**AGENDA
PLANNING COMMISSION
116 WEST NEEDLES
BIXBY, OKLAHOMA
October 06, 2015 6:00 PM**

- (2) 1. **PUD 91 – “The Village at Twin Creeks” – AAB Engineering, LLC.** Public Hearing, discussion, and consideration of a rezoning request for approval of a Planned Unit Development (PUD) for approximately 6 acres in part of the W/2 of the W/2 of Section 31, T18N, R14E.
Property Located: 11625 S. Mingo Rd.
2. **BZ-385 – AAB Engineering, LLC.** Public Hearing, discussion, and consideration of a rezoning request from AG Agricultural District to RS-2 Residential Single-Family District for approximately 6 acres in part of the W/2 of the W/2 of Section 31, T18N, R14E.
Property Located: 11625 S. Mingo Rd.

STAFF REPORT

To: Bixby Planning Commission
From: Erik Enyart, AICP, City Planner *EE*
Date: Thursday, October 01, 2015
RE: Report and Recommendations for:
PUD 91 – “The Village at Twin Creeks” – AAB Engineering, LLC &
BZ-385 – AAB Engineering, LLC

Exhibit B

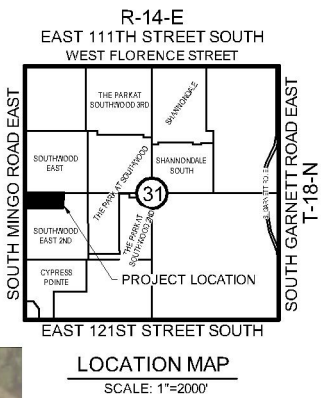
32. Exhibit B: Discrepancies with Preliminary Plat of "The Village at Twin Creeks" observed for certain dimensions and angle/bearing information. See especially within and along Reserve Area B and Lot 1, Block 1. Please reconcile or remove.
